To: URGWOM Technical Team
From: William J. Miller, Consulting Engineer
Subject: Technical Review Committee Comments on January 26, 2000 URGWOM Physical Model Documentation.

To: Members, URGWOM Technical team
From: William J. Miller, Consulting Engineer
Subject: Proposed Responses to Comments on February 27, 2001 URGWOM Documentation

To: URGWOM Technical Team
From: William J. Miller, Consulting Engineer
Subject: Proposed Responses to Technical Review Committee Comments on the June, 2002 URGWOM Documentation

To: URGWOM Technical Review Committee
From: URGWOM Technical Team
Subject: Technical Review of URGWOM Modifications

Figure 1 - Example of drain/canal x-section stream gage linked with bifurcation object.

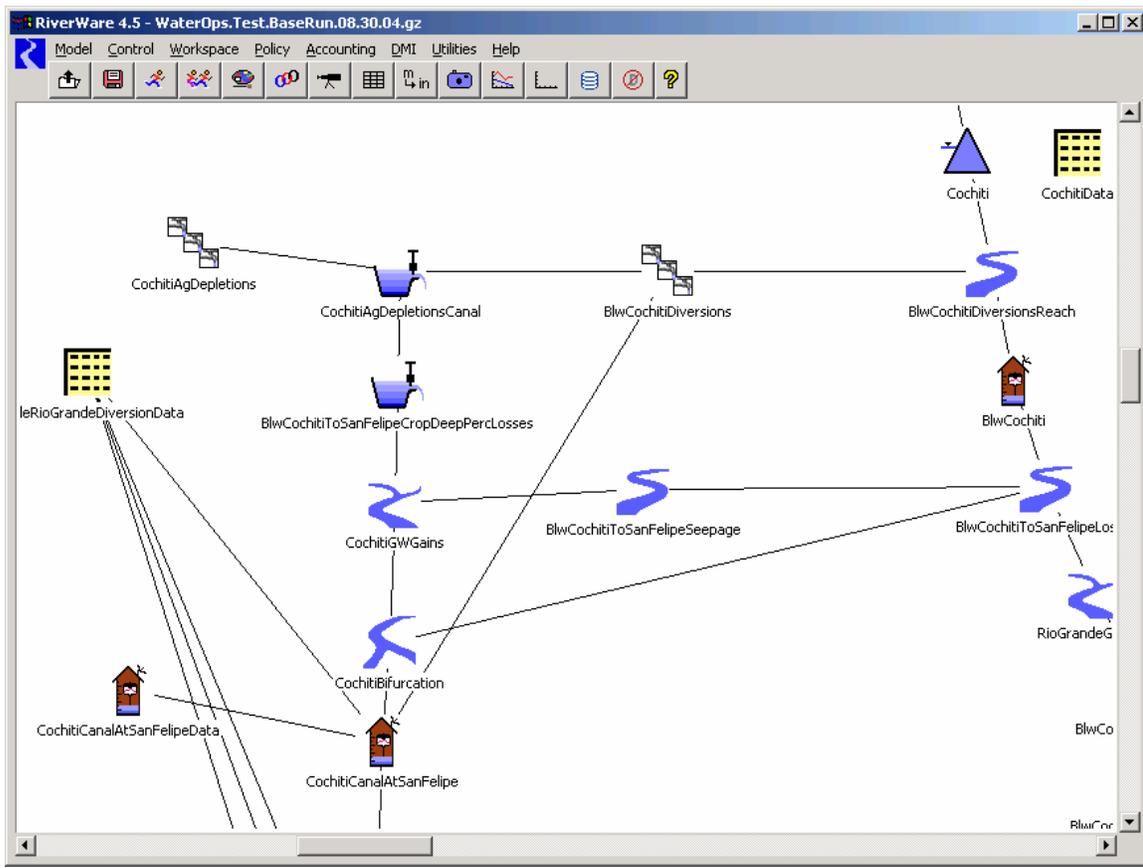
Another problem cropped up at the bifurcation objects (see Figure 1) in the middle valley where they are linked to downstream gage objects (at each canal/drain cross section), which are set by rules (based on historical flows at given cross-sections of the drain/canal system). The flows at these gages may need to be reduced when the original diversion request at an upstream diversion is not met (i.e., there is not enough water to meet the diversion request), using a relationship between the amount of water diverted upstream and the gaged flow below the bifurcation. These relationships were presented in a previous Technical Review (November 2003) and were set using rules (based on historical diversions). The gages at each canal/drain cross section (below the bifurcation objects) need to be set 5-10 days in advance (depending on the target location) for the hypothetical simulation (a predefined function in the RiverWare Policy Language) to be able to estimate required releases to meet the given target flow at the downstream location. Because the hypothetical simulation needs data 5-10 days out, a method (Stream Gage Conditional Flow Method) was required to set the values at the gage locations below bifurcation objects to replace previously used rules. The method replaces the rules that were developed to set the gage values based on the relationship between upstream diverted flows to what flows show up at the canal/drain gage location. CADSWES's document describing the Stream Gage Conditional Flow Method is in Appendix A.
